### AXLE TECH BULLETIN

For Axle Models: 170/190/590 Tri Drive ONLY

## Power Divider Lock-Out on the 1<sup>st</sup> axle

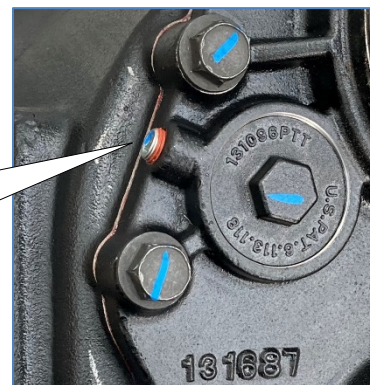
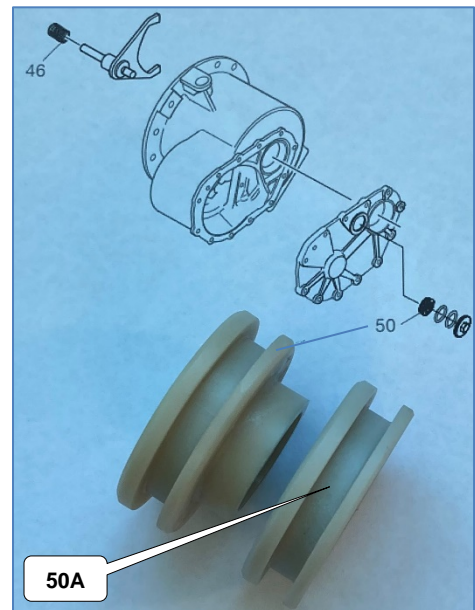
In the Dana Tri Drive Axle combination, the 1<sup>st</sup> axle (only) is fitted with a **locked power divider**.

To lock the power divider into the engaged position, an addition spacer is fitted in front of the piston.

**Item 50A:** 131232-MOD is the spacer fitted **additionally** to hold the piston in the engaged position.

Item 50: 131232 Piston

**Note:** Item 46 (Spring 129859) is not fitted in a locked power divider.

**Note:**  
The air supply hole to the piston is plugged.  
No air supply is required.
